**Preliminary Plan No. 120160150, Beallmount Grove, Parcel 2 (Resubdivision)**

**Preliminary Plan No. 120160150, Beallmount Grove, Parcel 2:** Request to create three lots from one platted parcel; located at 12901 Three Sisters Road; 9.6 acres; RE-2 zone; Potomac Subregion Master Plan.

**Staff Recommendation** – Approval with conditions

Figure 4 – Location of specimen

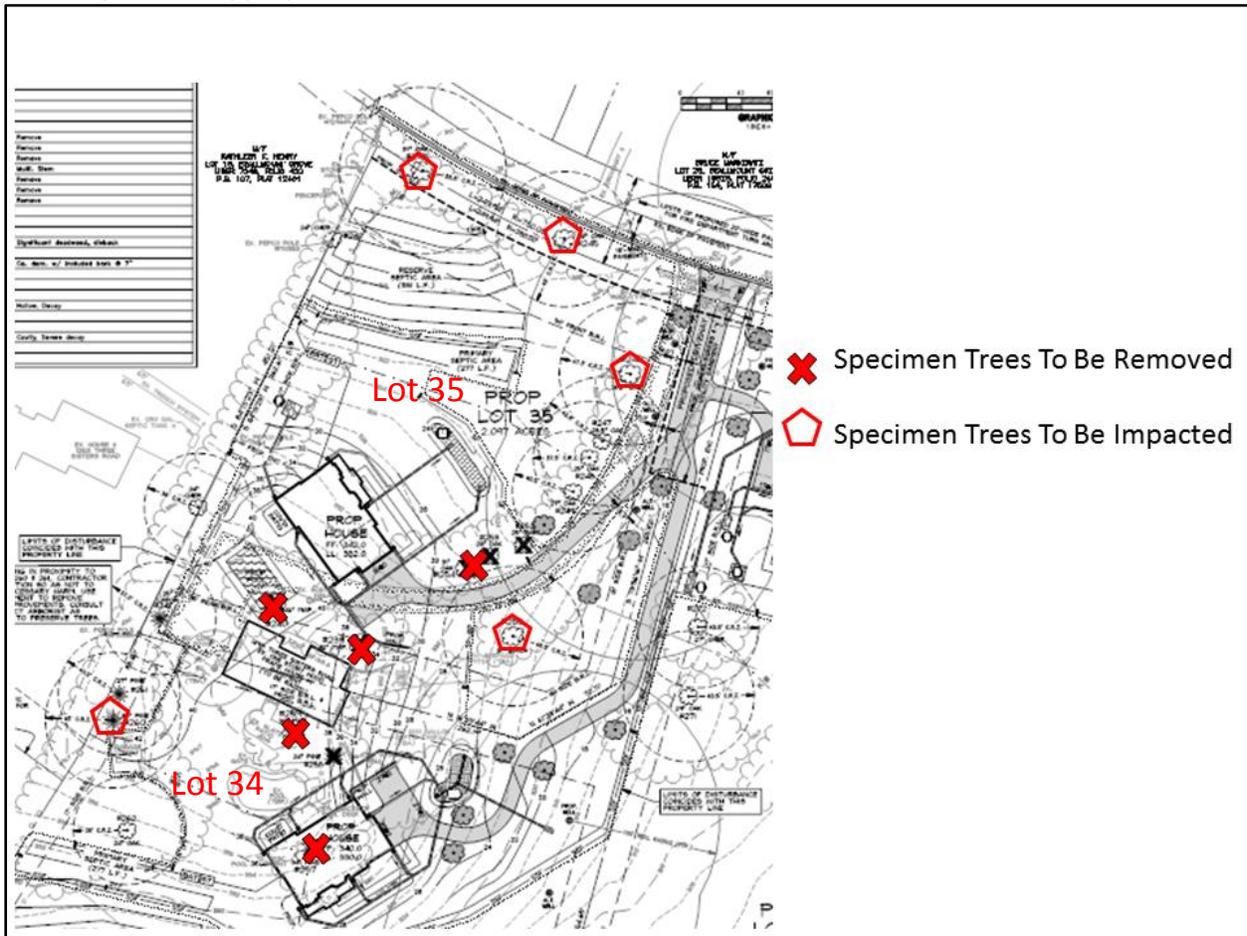
The Potomac Subregion Master Plan recommends RE-2 zoning for this area with no sewer or water access. As a result, development of this Site must rely on well and septic systems. The location of the proposed homes is dictated by the location of the wells and septic systems and the building restriction lines on each of the lots. Lot 35 is particularly constrained in this regard, which results in the unavoidable impacts to four trees and the removal of three trees. Lot 34 in turn also impacts one tree and will require the removal of two trees. Trees numbered 243 and 245 are located within the right-of-way of Three Sisters Road and due to a safety requirement by MCFRS both of these trees will have their critical root zones impacted (Figure 4).

The arboriculture industry standard for construction impacts to trees is to limit those impacts to no more than approximately 30 percent of the Critical Root Zone (CRZ). Beyond 30 percent impact to the CRZ and the overall viability of the tree can be diminished. Trees #239, #240, #254, #257 and #259 are proposed to have 92 percent to 100 percent of their respective CRZs impacted and these trees should be removed. Trees #243, #245, #246, #255 and #260 will have approximately 30 percent of their CRZs impacted and are expected to recover from this damage given the appropriate follow-on care.

There are five trees proposed for removal in this variance request, which when added together results in a total of 183 inches of DBH being removed. For removal of specimen trees associated with a variance request, Staff recommends mitigation for the tree loss by replacing  $\frac{1}{4}$  of the total number of DBH removed with replanted trees. This results in a total mitigation of 45.75 inches of replanted trees. In this case, the Applicant proposes to plant fifteen 3" caliper overstory trees native to the Piedmont Region of Maryland on the Subject Property outside of the right-of-way for Three Sisters Road, outside of any utility easements and these trees are not to be counted as an element of the Site screening requirements.

**PRELIMINARY/FINAL FOREST CONSERVATION PLAN**

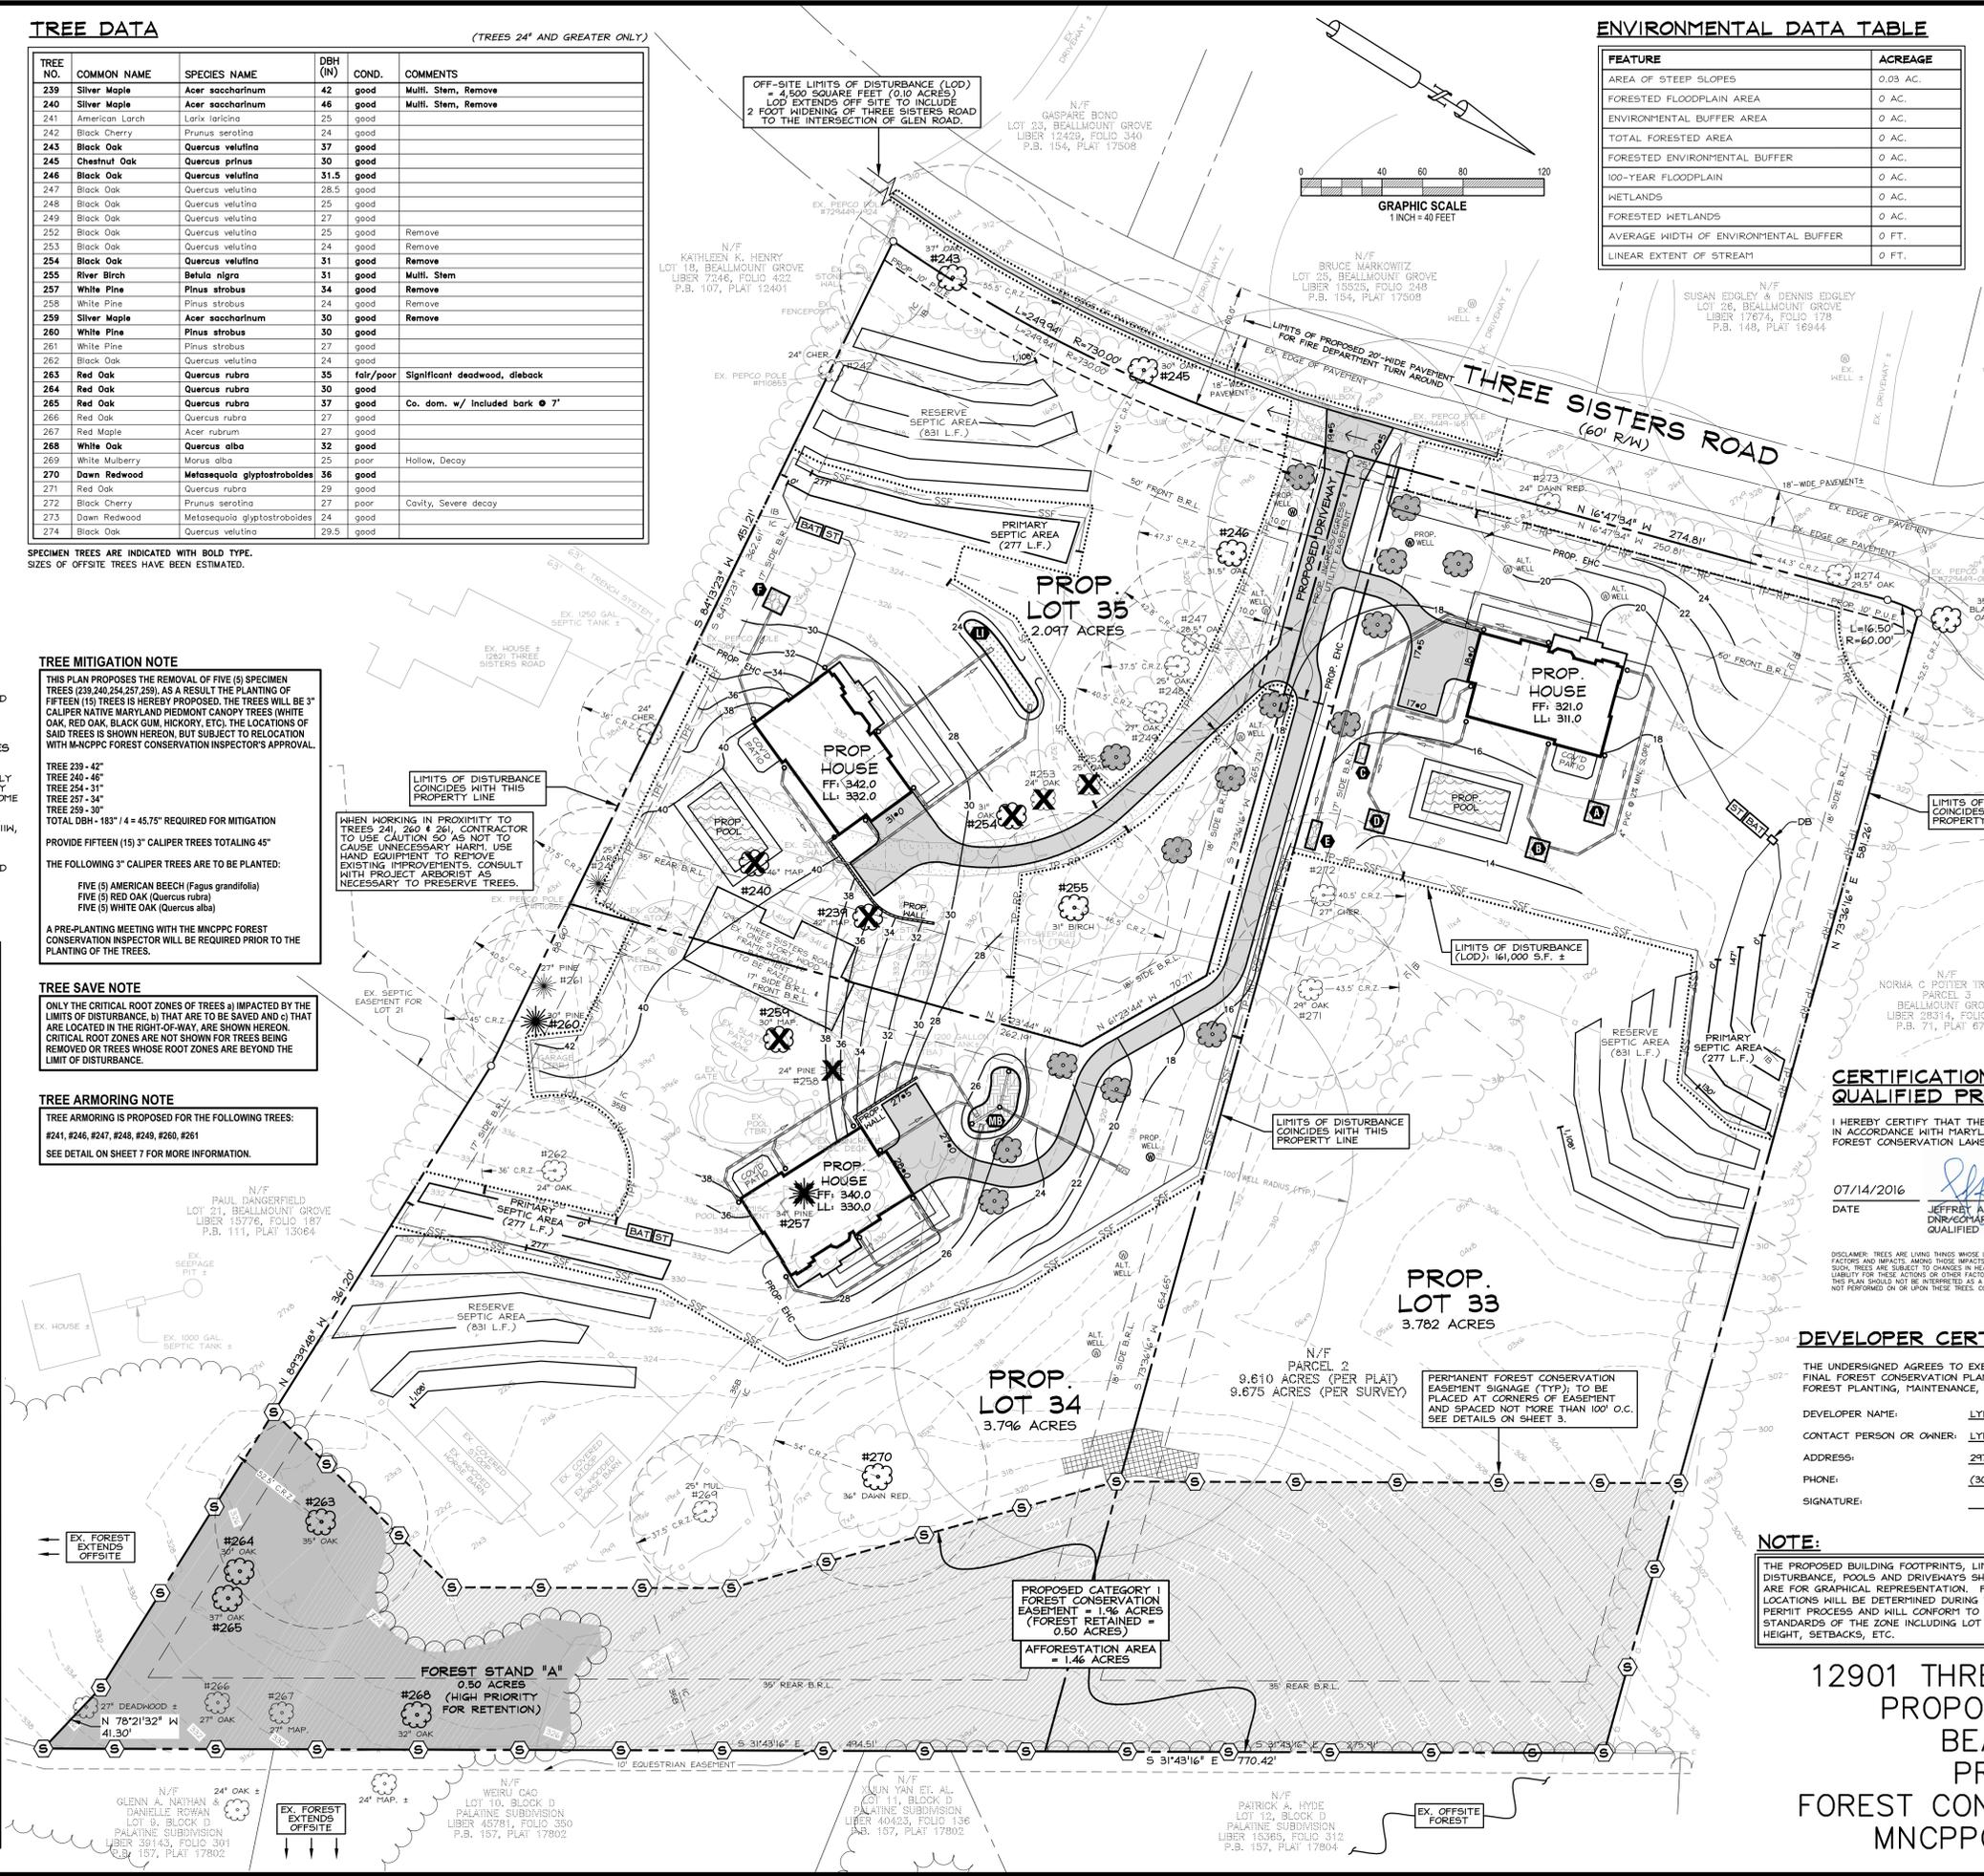
THIS PLAN PROPOSES THE REMOVAL OF FIVE (5) SPECIMEN TREES (239, 240, 254, 257, 259), AS A RESULT THE PLANTING OF FIFTEEN (15) TREES IS HEREBY PROPOSED. THE TREES WILL BE 3" CALIPER NATIVE MARYLAND PIEDMONT CANOPY TREES (WHITE OAK, RED OAK, BLACK GUM, HICKORY, ETC). THE LOCATION OF SAID TREES IS SHOWN HEREON, BUT SUBJECT TO RELOCATION WITH MNCPPC FOREST CONSERVATION INSPECTOR'S APPROVAL.

TREE ARMORING IS PROPOSED FOR THE FOLLOWING TREES: #241, #246, #247, #248, #249, #250, #261  
SEE DETAIL ON SHEET 7 FOR MORE INFORMATION.
